STAFF REPORT  
(One-Step Final Plat)

**CASE NUMBER:** SUB 2001-118 - FOREST RIDGE ESTATES

**EQUUS BEDS GROUNDWATER MANAGEMENT DISTRICT NO. 2  
GROUNDWATER QUALITY PLANNING STATEMENT**

**CONCERNING  
FOREST RIDGE ESTATES ADDITION**

VICINITY MAP

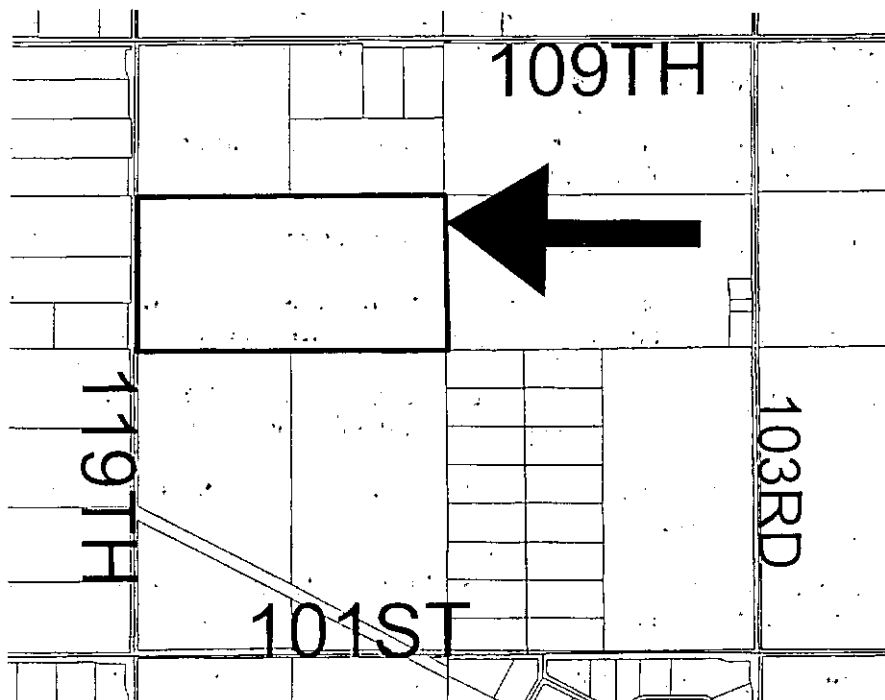
**Note:** This site is located in the County in an area designated as "rural" by the 1999 Update to the Wichita-Sedgwick County Comprehensive Plan. The applicant has requested a zone change (ZON 2001-72) to SF-20, Single-Family Residential to allow for the lot sizes being platted.

This site is located within a one mile radius of five City of Wichita Community wells. The applicant is advised that the City Water and Sewer Department, Equus Beds Management and MAPD have recommended denial of this plat due to concerns regarding groundwater contamination from septic tanks in this area.
